Accessibility Assessment:

Art Gallery of Peterborough

December 5, 2013

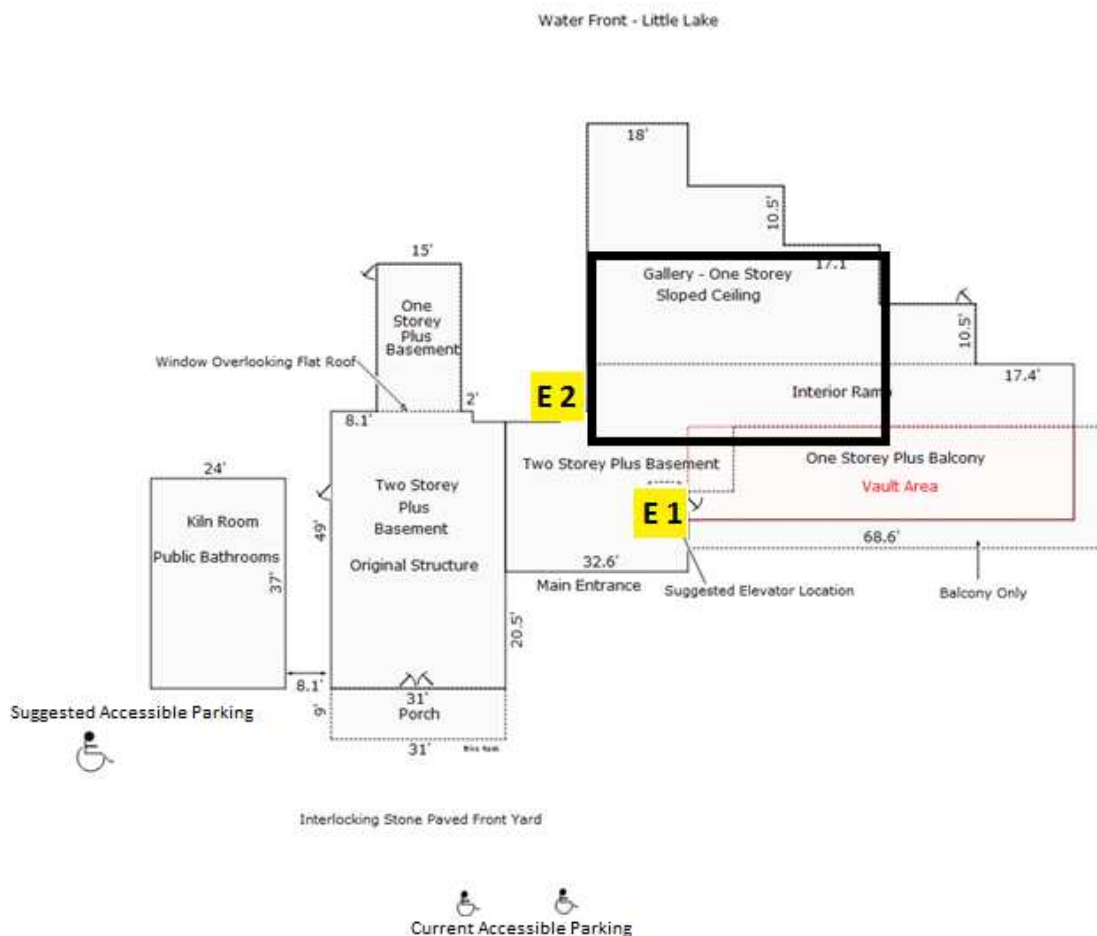
The overall length of the ramp and the placement of the washrooms on the main and lower levels of the building turn one of the best accessibility features in the building into a negative point. An individual in a wheelchair using the upstairs classroom area that needs to use the washroom could have to travel approximately 1000 feet to travel to the lower level washrooms and back to rejoin his/her class. If they were attempting to go to the main floor washrooms they would be faced with a challenge to use them since the main floor washrooms have 29" doorways. In order to improve overall access to features in the building and travel time to get to the various parts of the gallery we recommend the installation of an elevator that would access all three floors. We've identified three options to consider for this project.

Option 1 (E1): Add an internal elevator to the right of the main entrance to the building in the area where the coat rack currently exists.

Option 2 (E2): Place external mounted elevator directly across from the main entrance so you were facing it as you came through the front door. This would require attaching a new elevator shaft to the outside of the building such that it would become part of the building structure where the motorcycle artwork is currently located. This would cut off some visibility of the lake when you first come in but would maintain the site lines from the gift shop meeting area and would provide access to each of the floors without removing existing floor space from the building.

Option 3 (E3): In conjunction with either E1 or E2 an additional recommendation is to undertake a major retrofit project to remove the ramp system in favour of extending the gallery floor area. With the addition of an elevator described in the first two options the ramp system would no longer be necessary. While this project would be extensive it would open up several options for expanding the floor space available in the gallery thereby allowing for more exhibits to come through and providing more enjoyable access to the artwork currently housed along the ramp. If the option was considered to reclaim the space used by the ramp and use an elevator it would also open up the option for an architectural review of including a partial main floor gallery area by using space over top of the current gallery area and the space currently occupied by the ramp. The box on the image illustrates the potential for additional main floor gallery space if reclaiming the ramp
